**CONSTRUCTION BULLETIN
No. 1**

Institution: Calipatria State Prison - CAL

Reference: Project #18-045, Replace Roof, Phase 11, including

Description: This bulletin is to revise the roof slope to the existing ¼” per foot and to revise the parallel AHU’s crickets to 1 ½” per foot on the upper roof per RFI 003 response. Plans and Sections have been revised show the updated roof slope. Parapet,

APPROVALS

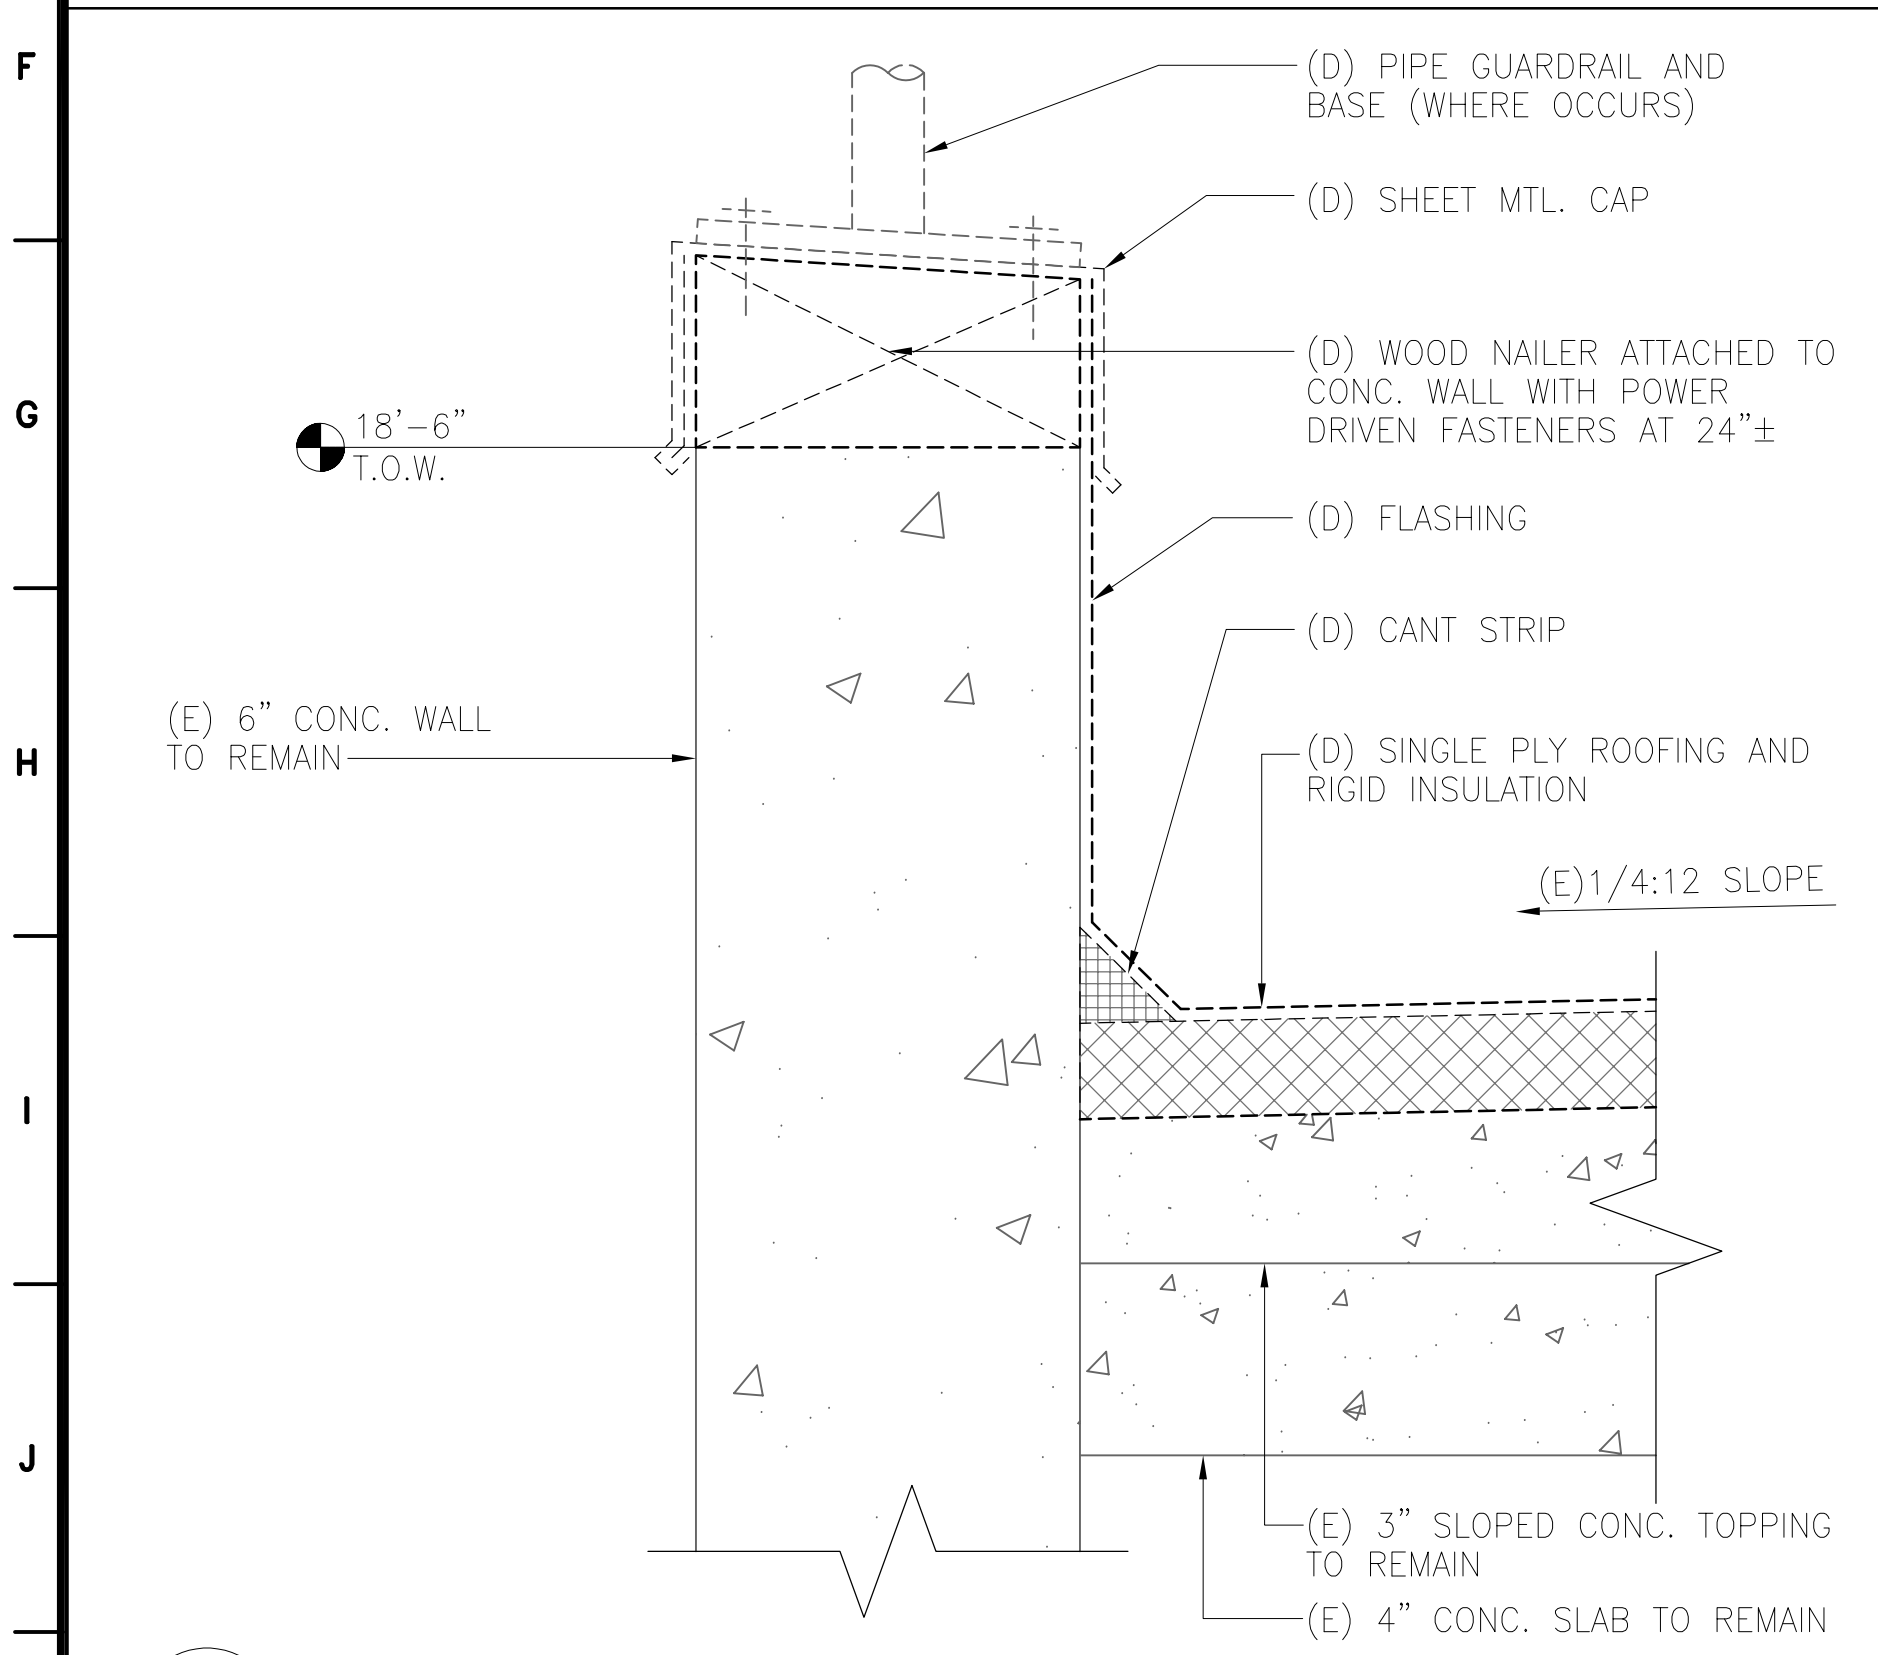
- a. Revised parapet detail to reduce parapet height per reduction of roof slope. See detail 1B/GA4.1.
8. Sheet GA4.2:
 - a. Revised roof edge condition detail per revised roof slope, see detail 3/GA4.2 and 5B/GA4.2.

2 GUARDRAIL AT PARAPET

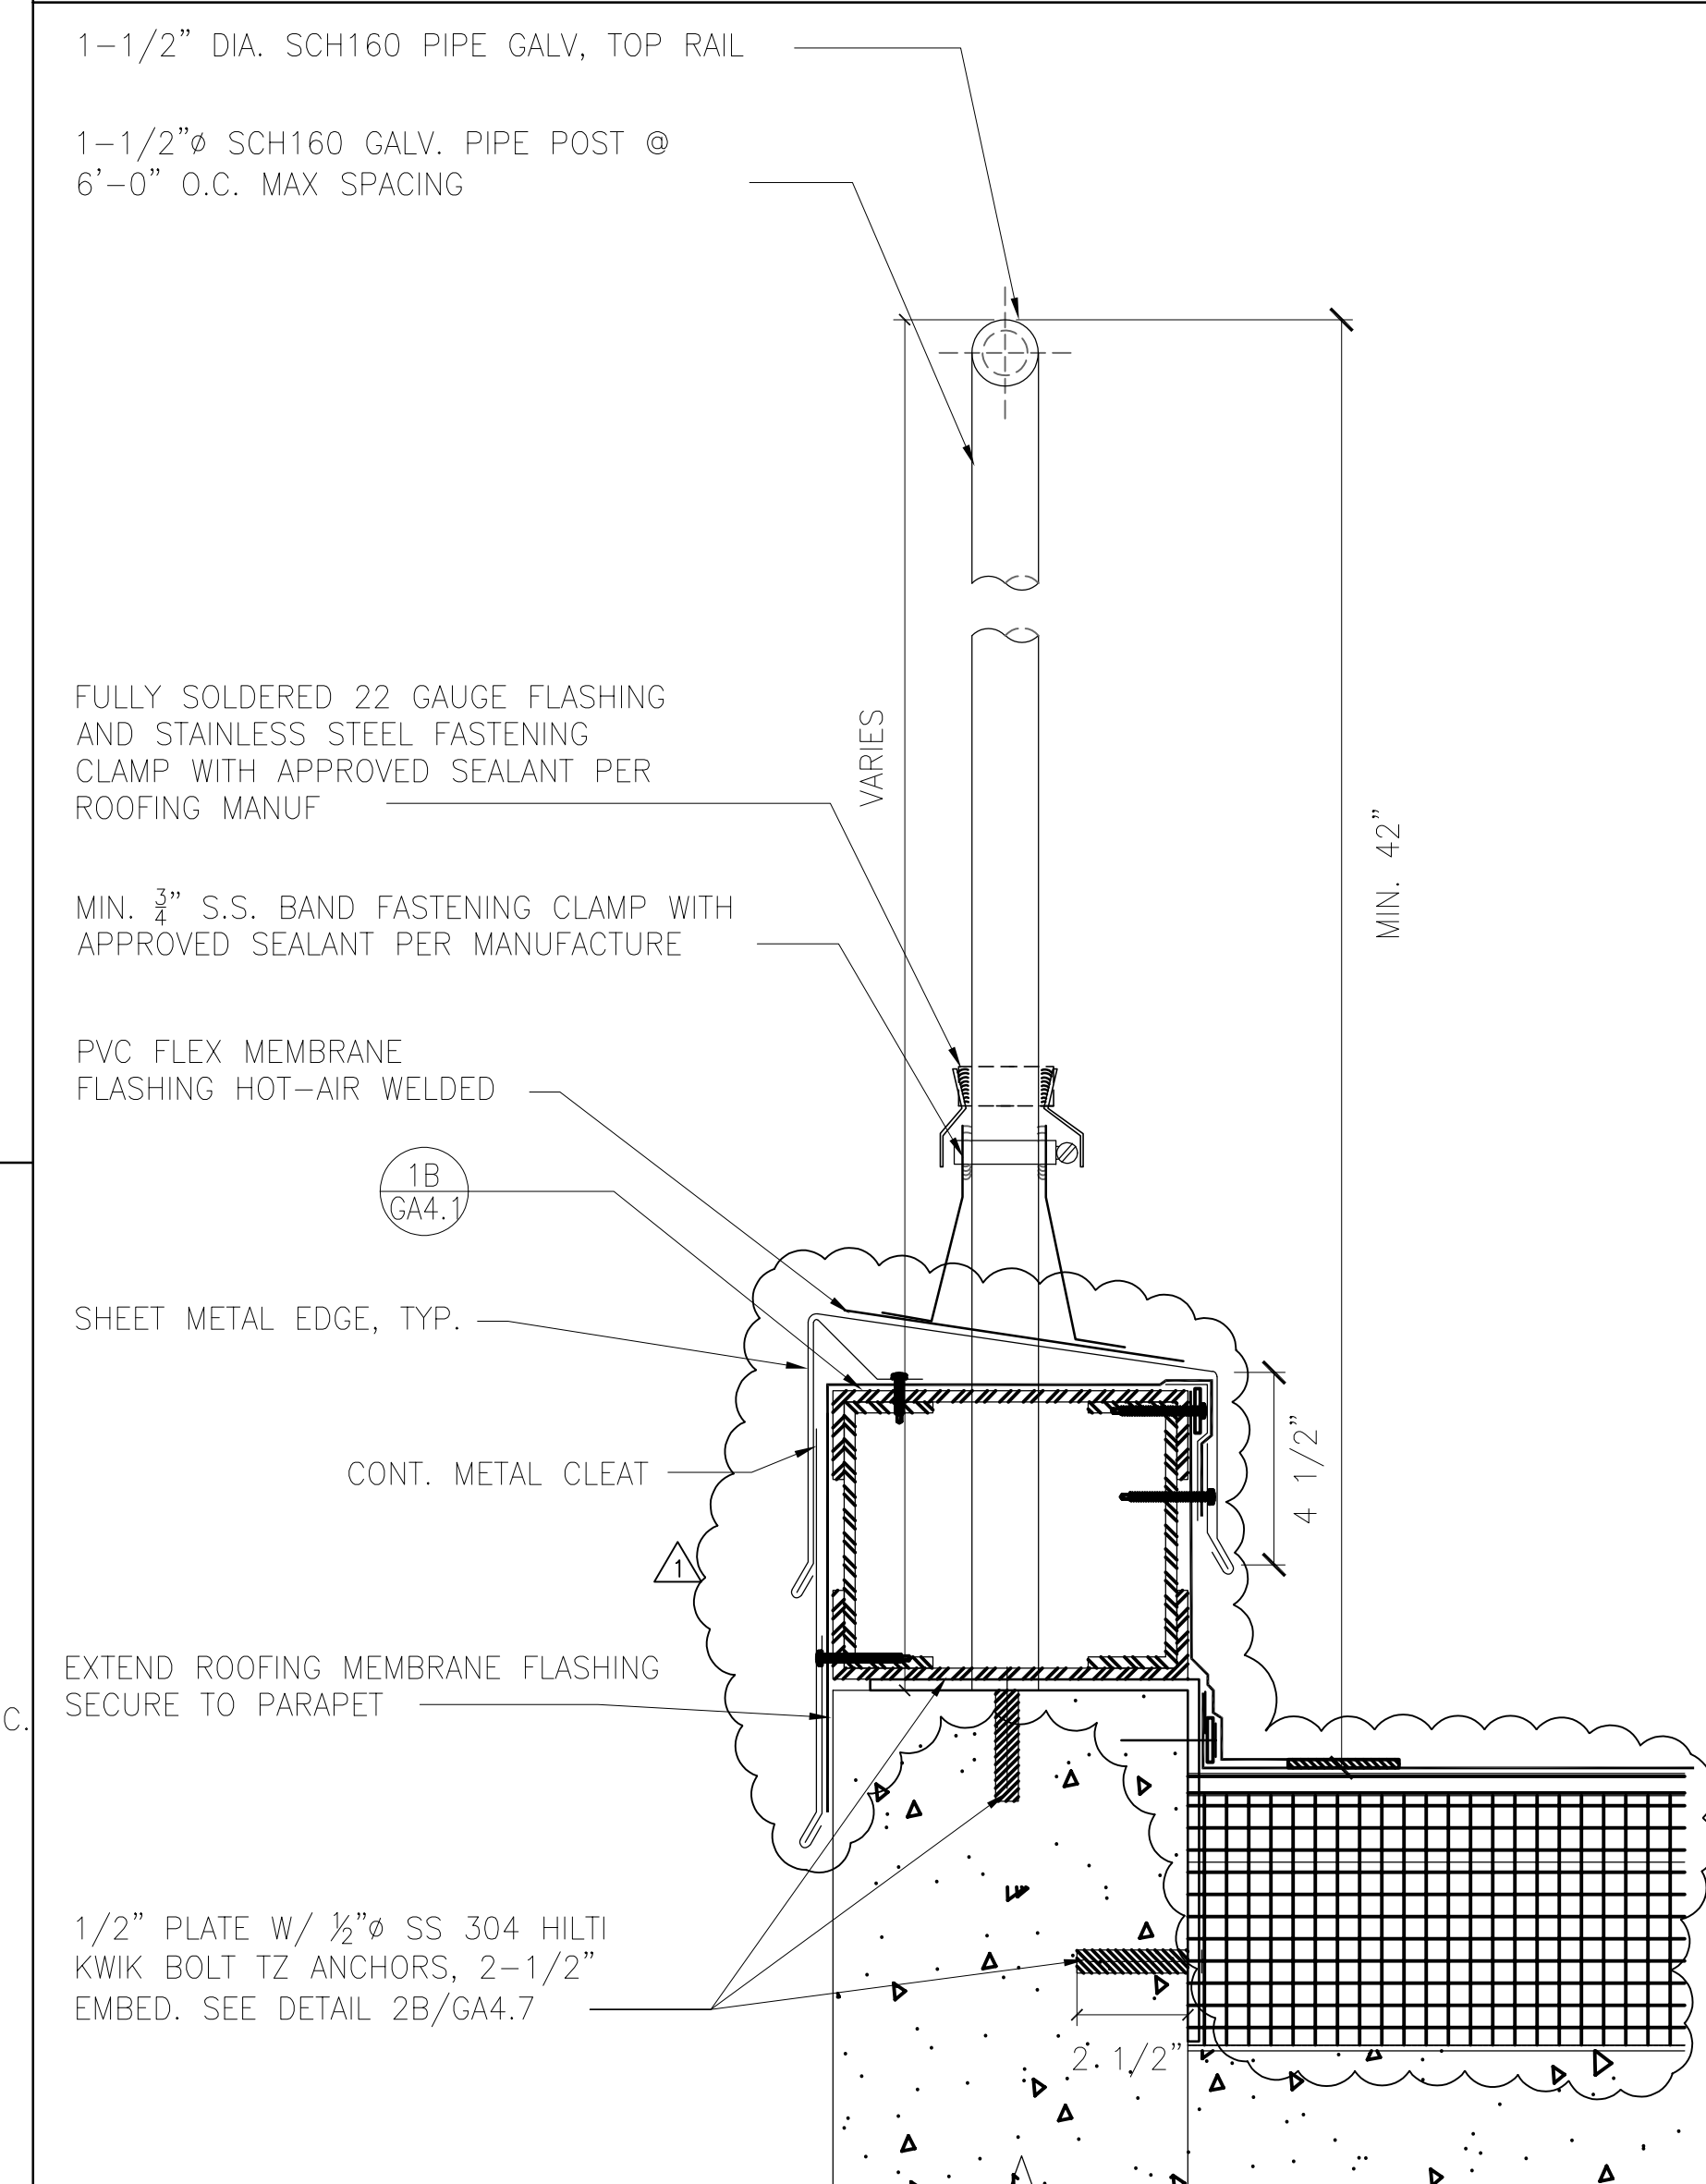
10. Sheet GA4.7:
 - a. Revised parapet framing per revised roof slope, see detail 2/GA4.7
11. Sheet HA2.0:
 - a. Revised roof slope to $\frac{1}{4}$ " per foot.

1 OVERALL NEW WORK ROOF PLAN - BUILDING 322 (PHASE-2)
HA2.0 SCALE: 0 4 8 FEET 16
1/8" = 1'-0"

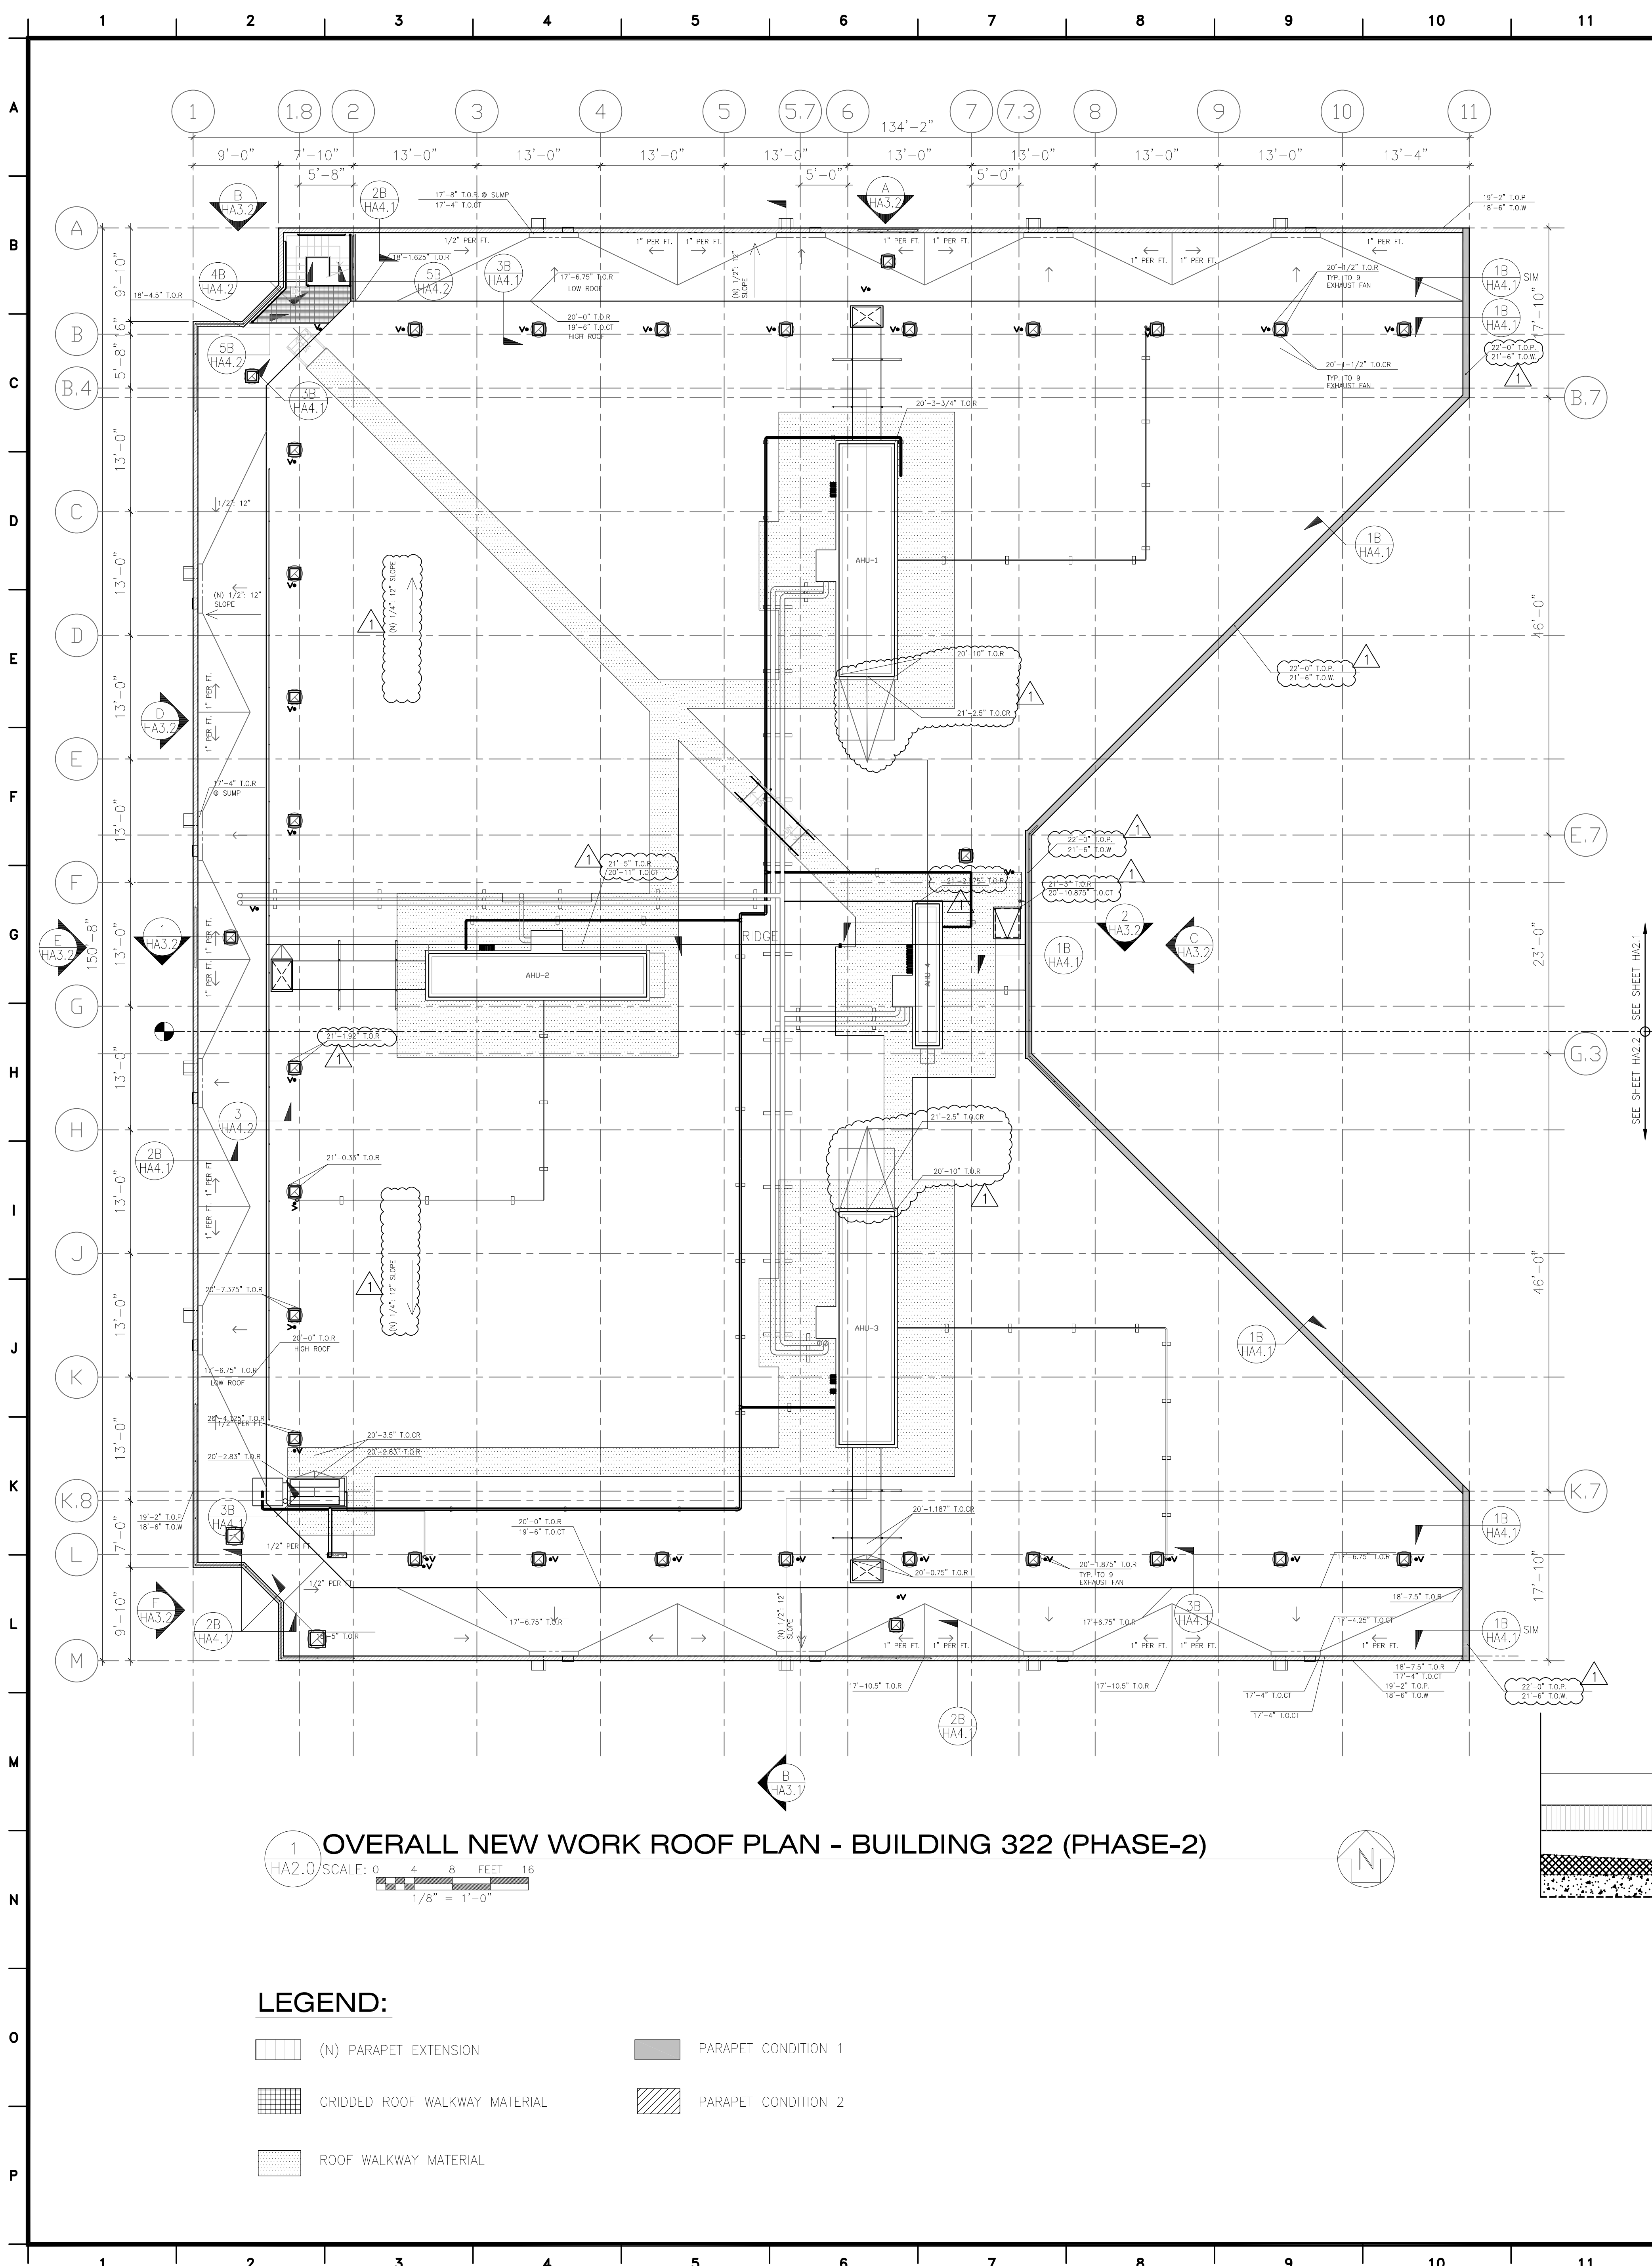
- b. Revised cricket slope at upper roof AHU to be 1 $\frac{1}{2}$ " per foot.
 - c. Revised spot elevations and parapet height on upper roof.
12. Sheet HA2.1:
